## Certificate of Appropriateness

2245 N. LAKE DR. North Point South HD

PTS ID 114738 COA: roof and gutters

Subject chimney at left

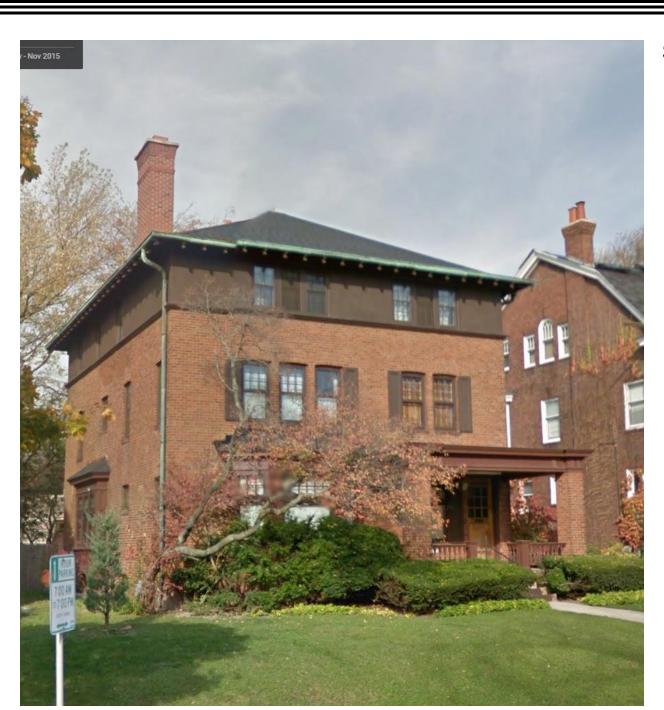
3. Install roof saddle at chimney as necessary, color-matched to roofing material, step-flashing

is required per conditions below.

No dormers, chimneys, moldings or other permanent features will be altered or removed. No box vents, if used, will be visible from the street. If they are installed, they must be on a rear slope not visible from the street and they must be painted to blend with the color of the roofing material. A continuous ridge vent can be installed in place of box vents, but the vent must extend across the entire ridge and not stop short. Built-in rain gutters will be retained and sealed where needed. Valleys must be metal W-shape with no interweaving of shingles. Valleys and flashing must be painted or factory-finished to match the roofing color, unless copper. When installing new flashing at a masonry feature, the flashing must be stepped or cut into the mortar joints. The bricks may not be cut to install flashing at an angle.
